Service Letter No. 370

SUBJECT: Modification to Engine Breather Line

MODELS AFFECTED: PA-24 and PA-24 "250" Comanches - Serial Numbers 24-2175, 24-2299 to 24-2675 incl., 24-2677 to 24-2801 incl., 24-2803, 24-2804, 24-2806, 24-2808 to 24-2888 incl., 24-2890 to 24-2935 incl., 24-2937, 24-2939 to 24-2943 incl., 24-2945 to 24-2948 incl., 24-2950 to 24-2956 incl., 24-2958 to 24-2966 incl., 24-2969 to 24-2982 incl., 24-2984, 24-2986 to 24-2989 incl., 24-2991, 24-2992, 24-2994 to 24-3005 incl., 24-3007 to 24-3009 incl., 24-3011, 24-3012, 24-3014, 24-3016, 24-3018, 24-3020 to 24-3023 incl., 24-3027 to 24-3040 incl., 24-3042, 24-3043, 24-3046 to 24-3049 incl., 24-3052, 24-3055, 24-3059, 24-3060, 24-3062, 24-3068.

# SERVICE LETTER NO 370

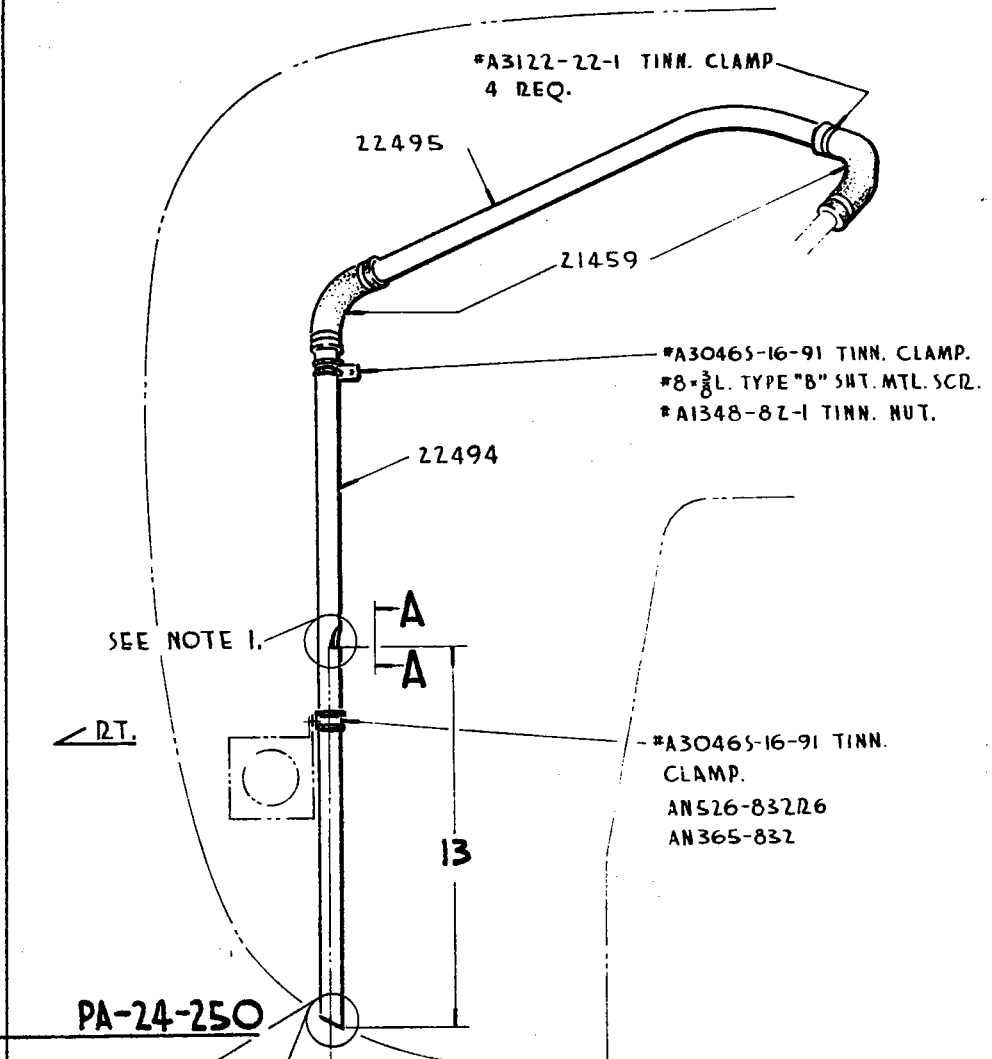
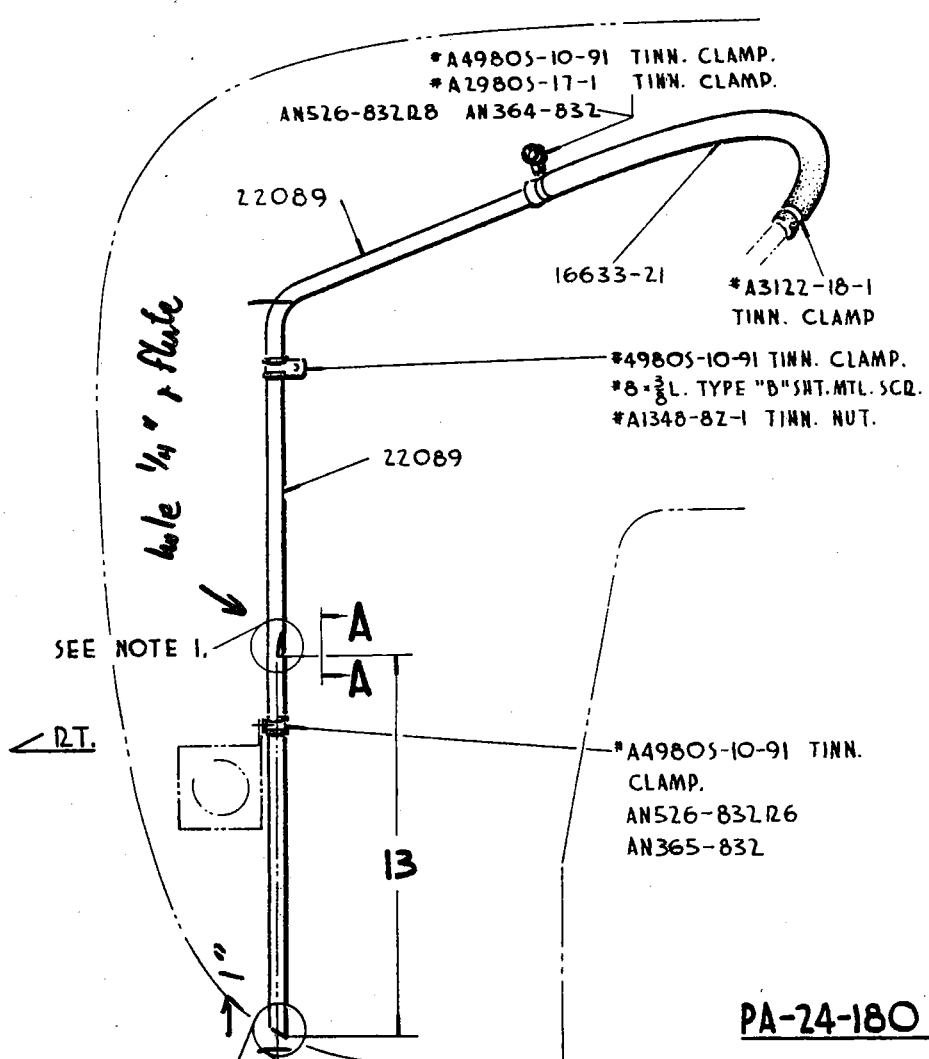
The engine breather line should be inspected and, if necessary, adjusted so that it is flush with the bottom cowl. Refer to sketch on the reverse side of this Service Letter. The adjustment of this breather line, flush with the bottom cowl, will prevent the accumulation of ice at the opening of the engine breather line and in the scoop into which it vents.

As a precautionary measure, for operations in extensive icing conditions it is recommended that the engine breather line be modified to provide an alternate vent. This modification consists of a saw-cut across the engine breather line and forming the area above the saw-cut as shown in the sketch on the reverse side of this Service Letter.

NOTE: CARE SHOULD BE EXERCISED WHILE FORMING THE VENT  
SO THAT THE TUBE IS NOT FLATTENED OR DISTORTED.

1. REMOVE BURRS THAT MAY BE FORMED AT END OF SAW SLOT.
2. ADJUST OIL BREATHER TUBE FLUSH WITH SKIN.
